To: T10 Technical Committee
 From: Rob Elliott, HP (elliott@hp.com)
 Date: 22 February 2004
 Subject: 04-032r1 SAS-1.1 ALIGNs through expanders

Suggested changes to SAS-1.1

Figure 1 — 1.5 Gbps to 3.0 Gbps connection

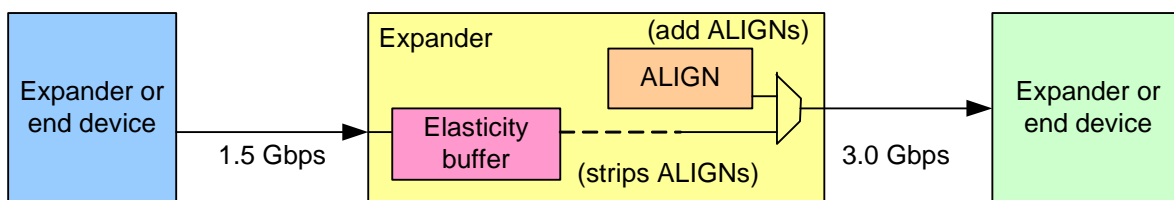
When an expander is forwarding dwords from a 1.5 Gbps link to a 3.0 Gbps link and inserting rate matching ALIGNs, the clock skew management ALIGN frequency requirement of 1 ALIGN every 2048 dwords cannot be met. Figure 1 shows the scenario.

As the expander forwards the dword stream, it has to insert rate matching ALIGNs as required on the 3.0 Gbps link to make up for underflows in the input 1.5 Gbps stream - 1 ALIGN every 2 dwords. Essentially, the transmitter underflows a lot. It is not allowed to buffer up N dwords and burst them out together, followed by N ALIGNs - it is required to dole out the ALIGNs every other dword so the receiver of the data is not required to have lots of extra buffering.

Additionally, The 1.5 Gbps source transmits 1 ALIGN every 2048 dwords for clock skew management (i.e., clock frequency tolerance compensation). Each of these ALIGNs creates additional underflows in the expander that consume two 3.0 Gbps dword widths of time. The expander probably sends the two 3.0 Gbps ALIGNs back-to-back. It could also scatter them, but that requires extra buffering in the expander.

Figure 2 — ALIGNs on the links

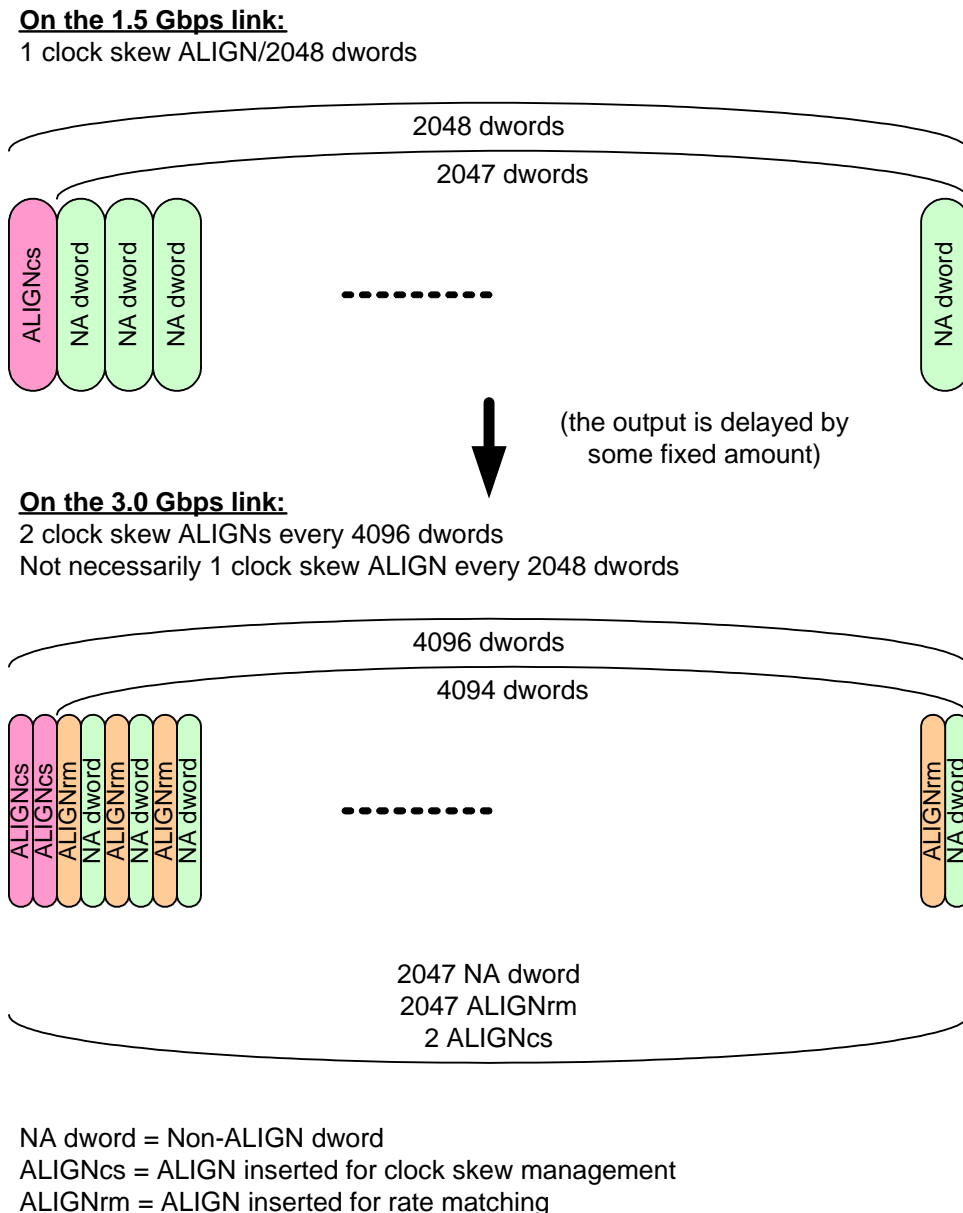
Figure 2 shows the dword stream on each physical link.

Of the 4094 dwords on the 3.0 Gbps link that are not the two clock skew ALIGNs, 2047 are the non-ALIGN dwords from the 1.5 Gbps link and 2047 are the rate-matching ALIGNs. There are no clock skew ALIGNs in that group - they appeared at the beginning (of the 4096 dword window).

So, on the 3.0 Gbps link, all that can be guaranteed is 2 ALIGNs every 4096 dwords, not 1 ALIGN every 2048 dwords. There are many 2048 dword windows where those ALIGNs might not both appear (inside the 4094 dword window). For 6.0 Gbps (in SAS-2), the ratio will grow to 4 ALIGNs every 8192 dwords.

These ratios are all the same when considered over at least the time it takes to transmit the original 2047 non-ALIGN dwords (e.g. the 4096 window on a 3.0 Gbps link). Over any shorter term (e.g. a 2048 window on a 3.0 Gbps link), however, the ratio cannot be guaranteed.

A phy that is the original source for the dword stream (i.e., a phy that is not an expander phy forwarding dwords from another expander phy) shall insert one ALIGN or NOTIFY for clock skew management ~~within every 2 048 dwords (i.e., every overlapping window of 2 048 dwords)~~ [as described in table 1.](#)

Physical link rate	Requirement
1,5 Gbps	One ALIGN or NOTIFY within every 2 048 dwords
3,0 Gbps	Two ALIGNs or NOTIFYs within every 4 096 dwords
